**Inspection Report
420-426 Pitt Street, Haymarket**

Council investigation officer Inspection and Recommendation Report
Clause 17(2), Part 8 of Schedule 5, of the Environmental Planning and Assessment
Act 1979 (the Act)

**Re: INSPECTION REPORT
MOSAIC
420 PITT STREET HAYMARKET ("the premises")**

Figure 1 - Example Boost Pressure signage.

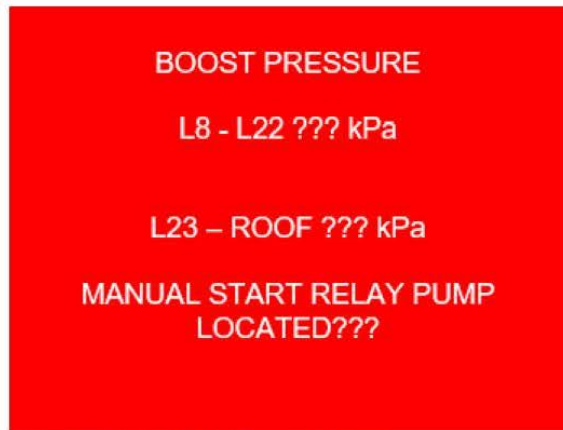
Boost and test pressure signage is not installed at the hydrant booster cabinet to advise the fire brigade of boost pressure to provide 700 kPa at the most hydraulically disadvantaged hydrant in each pressure zone or the required pressure for the relay pumpset.

- d. Multiple boost and test pressure signage should be installed at each boost inlet connection for each pressure zone as per Item 1A.B. above. The Zone 2 and 3 boost inlets connection should contain two pressures (see Figures 1 and 2).
